**RE: 5616 Cinder Cone Dr. NW  
Grading and Drainage Plan  
Engineer's Stamp Date: 08/26/19  
Engineer's Certification Date: 08/26/19  
Hydrology File: E10D064**

Based upon the information provided in your Certification received on 09/05/19 and site photos sent on 09/12/19, the above referenced Certification is acceptable for Building Pad Certification for 5616 Cinder Cone Dr. NW.

## DRAINAGE AND TRANSPORTATION INFORMATION SHEET (REV 6/2018)

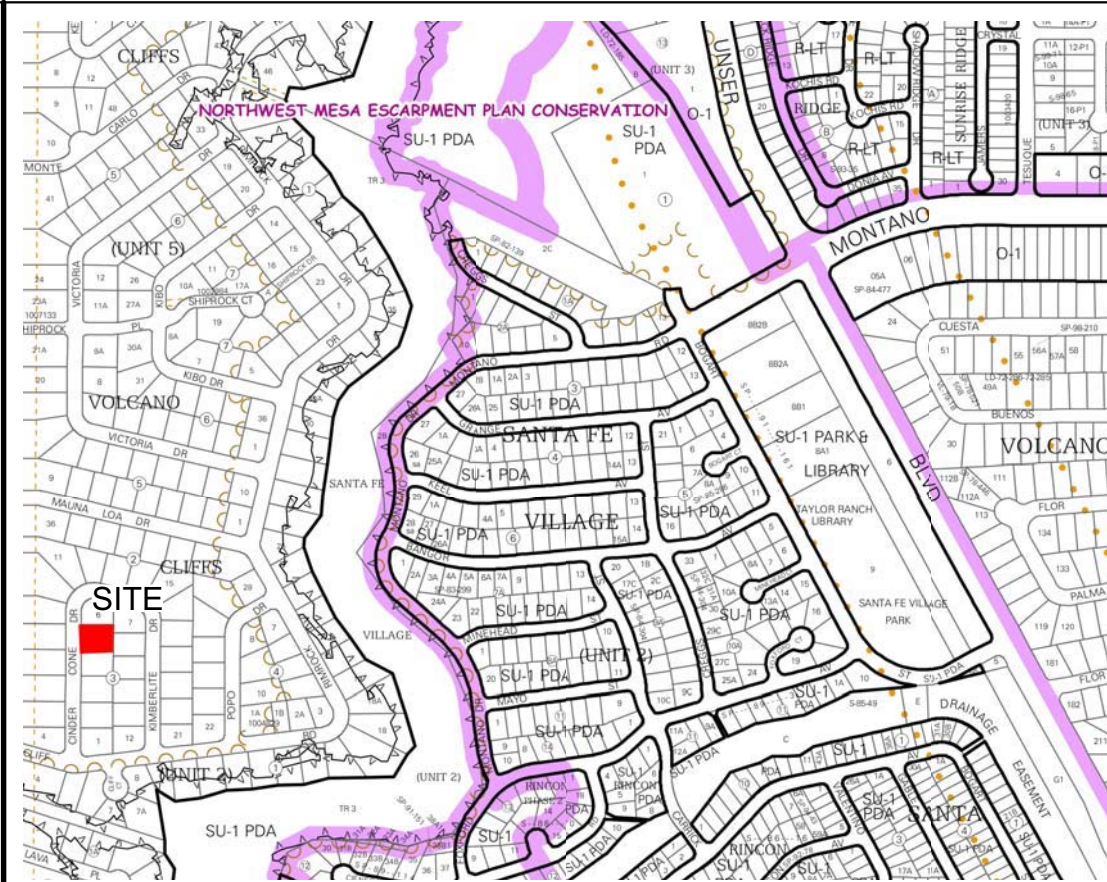
As a reminder, prior to approval in support of Permanent Release of Occupancy by Hydrology, Engineer Certification per the DPM checklist will be required.
